UNITED STATES PATENT AND TRADEMARK OFFICE

APPLICATION NO.	FILING DATE	FIRST NAMED INVENTOR	ATTORNEY DOCKET NO.	CONFIRMATION NO.
10/506,369	05/12/2005	Tillman Freudenberg	8470G-000023/NP	1073
27572	7590	12/08/2006	EXAMINER	
HARNESS, DICKEY & PIERCE, P.L.C. P.O. BOX 828 BLOOMFIELD HILLS, MI 48303			NGUYEN, XUAN LANT	
			ART UNIT	PAPER NUMBER
			3683

Office Action Summary

FIG. 5

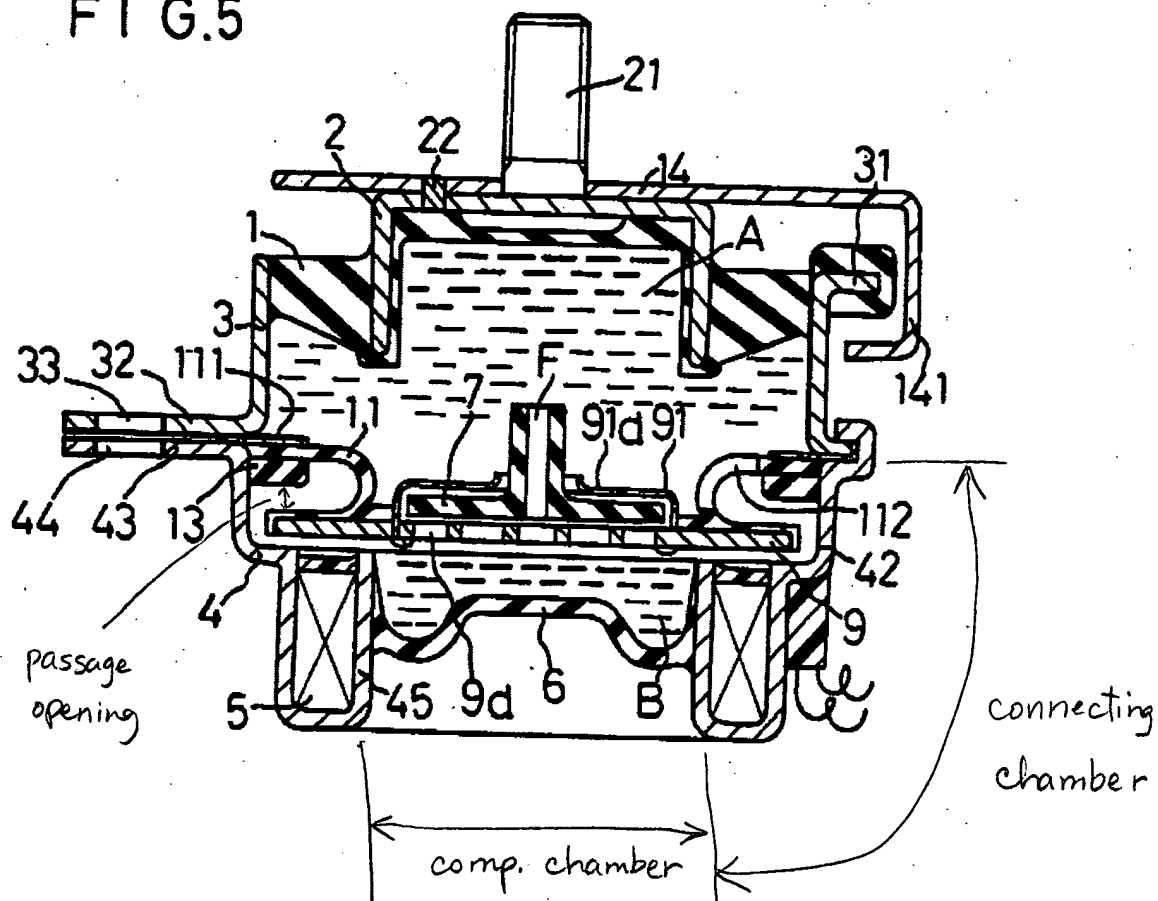
Re: claim 1, Ozawa shows a switchable assembly bearing with hydraulic damping, as in the present invention, particularly for supporting drive assemblies and/or gearbox assemblies in motor vehicles, comprising: at least one working chamber A and one compensation chamber B that are separated from one another by a dividing wall 11, said working chamber and said compensation chamber being hydraulically interconnected through a damping channel F, and at least one additional damping channel 112 that can be closed by means of a shut-off body 9 displaceable along a displacement path, said shut-off body being capable of providing a seal by contact with an associated seat 13, wherein said additional damping channel is configured and disposed relative to a symmetry axis of the bearing so that forces acting on said shut-off body through a hydraulic liquid counterbalance each other.

Re: claim 2, Ozawa further shows said damping channel 112 forms an aperture between the working chamber A and the compensation chamber B in the form of a radially surrounding annular slot with a passage opening disposed radially relative to said symmetry axis and directed toward said compensation chamber B, as marked

above, and that said shut-off body 9 is formed by a sealing ring disposed at said passage opening and is displaceable along a displacement path that extends vertical to said passage opening between an open position and a closed position.

Re: claim 3, as marked above, said passage opening points radially outward.

Re: claim 7, figure 5 also shows the electromagnet being disposed in a chamber as claimed.

Re: claim 9, figure 5 shows the additional damping channel is disposed within the dividing wall 11.

Re: claim 12, Ozawa shows a bearing assembly, as in the present invention, comprising: a working chamber A; a compensation chamber B, said compensation chamber in fluid communication with said working chamber through a first damping channel F; and a connecting chamber, as marked above, said connecting chamber

fluidly connecting said working chamber and said compensation chamber through a second damping channel 112; wherein said connecting chamber includes a sealing ring 9 that is movable between an open position and a closed position such that said sealing ring can open and close said second damping channel.
